75 - 1 - PRESTON 8 (30-1C) ELEV A
CABINETRY - BASE CABINETS

Lot 75-PRESTON 8-MAIN FLOOR

Preston 8-second floor

Sketch "A"

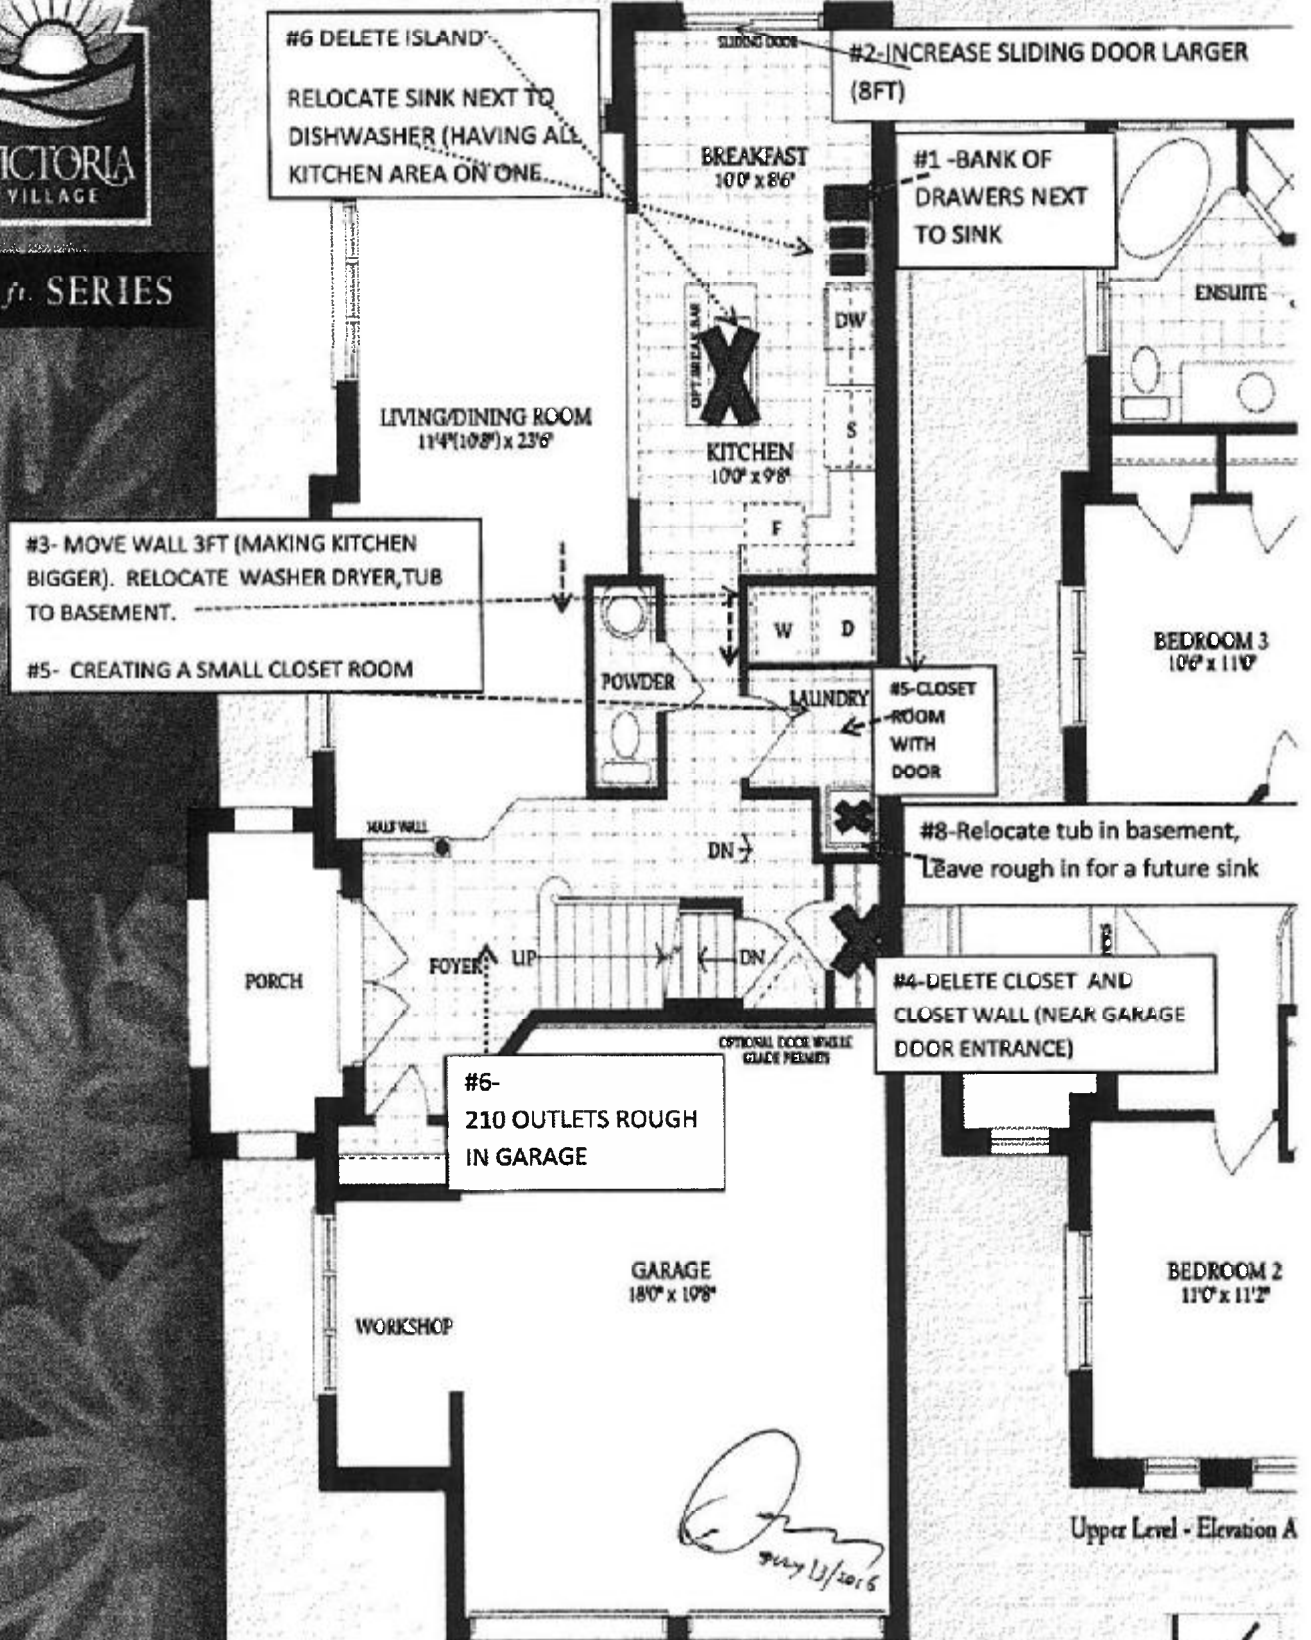
Inv.764	1 - BANK OF DRAWERS- 55 CM (SUBJECT TO FLOOR PLAN) NEXT TO SINK (IF POSSILE) SEE SKETCH "A"
Line9287	Note:
11May16 / 15Jul16

Inv.764	1 - INCREASE SIZE OF SLIDING DOOR (8FT) SEE SKETCH
Line8927	Note:
11May16 / 15Jul16

Inv.764	1 - MOVE WALL 3FT(INCREASING SIZE OF KITCHEN) RELOCATE WASHER/DRYER AREA WASHER/DRYER, TUB AND VENT TO BASEMENT SEE SKETCH"A"
Line8928	Note:
11May16 / 15Jul16

Inv.764	1 - DELETE CLOSET AND WALL IN HALLWAY NEAR ENTRANCE TO THE GARAGE. SEE SKETCH "A"
Line8929	Note:
11May16 / 15Jul16

Inv.764	1 - CLOSE OFF SMALLER AREA(LESS 3FT) OF PREVIOUS LAUNDRY ROOM(CREATING A SMALL CLOSET WITH A DOOR) SEE SKETCH "A"
Line9271	Note:
11May16 / 15Jul16

Inv.764	1 - SUPPLY AND INSTAL 210 OUTLET IN GARAGE. SEE SKETCH "A"
Line8930	Note:
11May16 / 15Jul16

Inv.764	1 - DELETE ISLAND AND , RELOCATE SINK NEXT TO DISHWASHER , (HAVE SINK , DISHWASHER, STOVE ALL AND EXISTING CABINETRY STANDARD ON ONE SIDE OF KITCHEN) . (SEE SKETCH "A")
Line9272	Note: PLUMBING NEEDS TO BE MOVED.
11May16 / 15Jul16

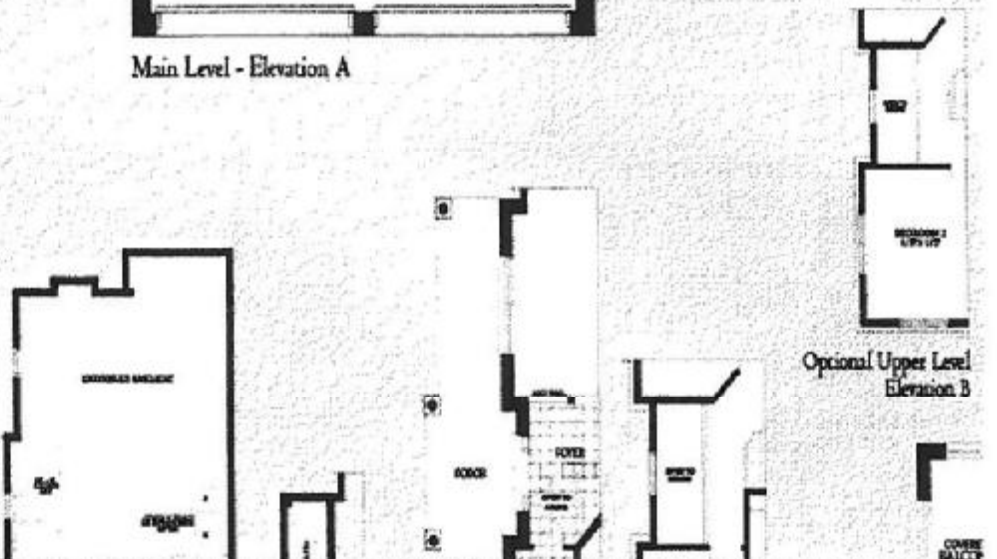
#1-(BEDROOM 2) DELETE WALL & CLOSET-

MOVE WALL OF WALK IN CLOSET GOING INTO FAMILY ROOM UP TO LEVEL WITH BEDROOM WALL

#3-(BEDROOM 3)-DELETE DOUBLE DOOR CLOSETS MOVING WALL IN, TO BE ABLE TO MOVE ENSUITE WALL OUT.
~SUPPLY AND INSTALL DOUBLE DOOR CLOSET ON WALL NEXT TO DOORWAY

#4-ENSUITE-MOVE ENSUITE WALL BACK (INTO BEDROOM 3 TO END OF CLOSET OR AS FAR AS POSSIBLE),
~RELOCATE SHOWER NEXT TO VANITY, AND TOILET NEXT TO TUB. TURN TUB FROM CORNER TO SIDE WALL

#2-(2ND FLOOR FAMILY ROOM/OPT BEDR 4)-ADD TOP OF THE WALL TO THE HALF WALL, AND PUT INSERT A DOUBLE DOOR CLOSET.
